Access Compliance Report

Public Rights-of-Way

(Curb Ramps)

Intersection ID: 3126	Main Street: BROWNESTONE_VIEW_DR	Cross Street: GALENA_VIEW_DR	Location: W
ADA ID: E452214C2F18	Ramp Type: Perp	Initial Pass/Fail: Fail	Overall Compliance: No
Severity Score: 12.5			
Codes/Mitigation Info/Possible Solution		Field Measurements/Component Compliance

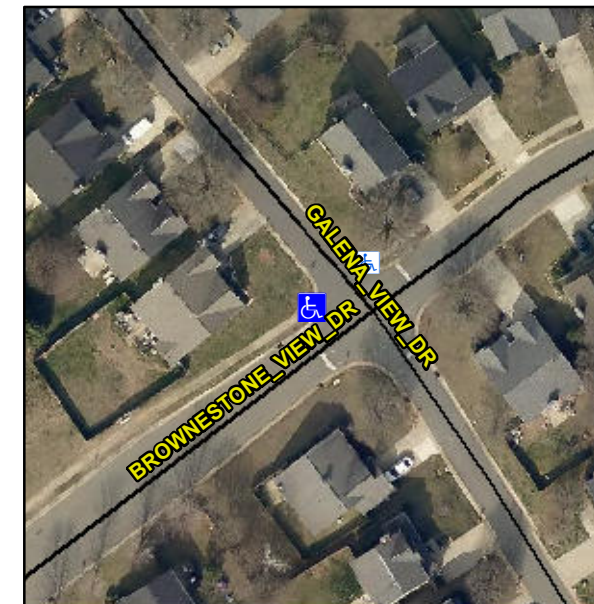
Not Found, R304.5.3

Compliance	Description	Data	Compliance	Description	Data
N/A	Ramp Length (in)	94.0	Yes	Ramp Slope (%)	5.0
Yes	Ramp Width (in)	48.0	No	Ramp XSlope (%)	5.9
N/A	Flare Type LT	N/A	N/A	Flare Type RT	N/A
N/A	Flare Slope LT (%)	N/A	N/A	Flare Slope RT (%)	N/A
N/A	Flare Traversable LT?	N/A	N/A	Flare Traversable RT?	N/A
N/A	Landing Length (in)	N/A	N/A	DWS Provided?	N/A
N/A	Landing Width (in)	N/A	N/A	DWS Contrast?	N/A
N/A	Landing Slope (%)	N/A	N/A	DWS Length (in)	N/A
N/A	Landing X Slope (%)	N/A	N/A	DWS Full Width?	N/A
N/A	Landing Curb? (Y/N)	N/A	N/A	DWS Offset (in)	N/A
N/A	Shared Landing?	N/A			
N/A	Gutter Ponding?	N/A	N/A	Gutter Slope (%)	N/A
N/A	Gutter Lip Ht (in)	N/A	N/A	Gutter X Slope (%)	N/A
N/A	Painted X Walk1?	No	N/A	Painted X Walk2?	N/A
	X Walk 1 Direction	To NE		X Walk 2 Direction	N/A
N/A	X Walk 1 Width (in)	N/A	N/A	X Walk 2 Width (in)	N/A
	X Walk 1 Slope (%)	0.3		X Walk 2 Slope (%)	N/A
	X Walk 1 X Slope (%)	5.0		X Walk 2 X Slope (%)	N/A

Remove & Replace Entire Ramp.
